Response by The Port of Mostyn to Hynet CCS PROJECT Liverpool Bay

NRW Application Ref CML2365

Volume 2 - CHAPTER 9 – SHIPPING & NAVIGATION

Figure 1: Anchor pattern for grounded and crawling CLV

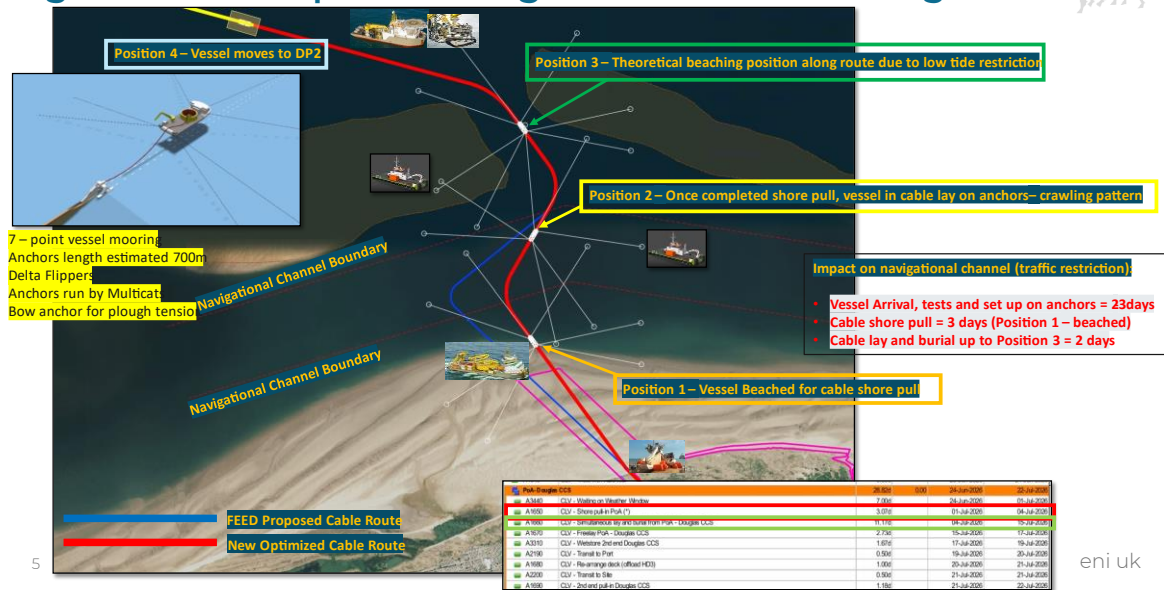
- (1) The statement that an average of 6 vessels per day accessed Mostyn is a gross understatement, the correct number is circa 12-14 vessels per day therefore the risk assessment should be reviewed accordingly.
- (2) The fact that an obstruction of the Welsh Channel will be localised is irrelevant, irrespective of the location of the obstruction, a blockage of the 1.5nm long channel will have serious implications for Mostyn and its shipping clients.
- (3) Will the Applicant please advise if it is anticipated that the cable laying operations at Point of Ayr will be carried out in one continuous operation during which the 500m safe passing zone will apply. If that is being planned, can they also please confirm the length of time when the cable laying vessel(s) will be operating within 500m either side of the Welsh Channel?

The current potential proposals for crossing the Welsh Channel are illustrated **Figure 1** below. The figure shows that there will be a seven (7) anchor spread around the CLV. Three to port, three to starboard, and a single cable off the bow. The bow cable will pull the vessel and the trailing plough to simultaneously lay and bury the cable. The cables to port and starboard will keep the vessel stable and prevent lateral movement thereby protecting the cable during the laying and burial process. This information has been added to section 2

There will be a 500m zone around the CLV within which movement by other vessels will be temporarily restricted via collaboration with the vessel captain and the port authority. The cable anchors will be marked by buoys and the repositioning of the anchors will be re-positioned out by three (3) shallow water multi-cats as shown in the Figure.

For the simultaneous lay and burial of the cable shown in the **Figure 1**, the CLV will traverse the Welsh Channel, pulled on anchors, over a period of approximately 12h-24 hours including potential weather standby.

Permission from the Port of Mostyn will be gained prior to marine works in the channel commencing. The Cable Lay Contractor and ENI will endeavour to minimise the time the channel is obstructed.
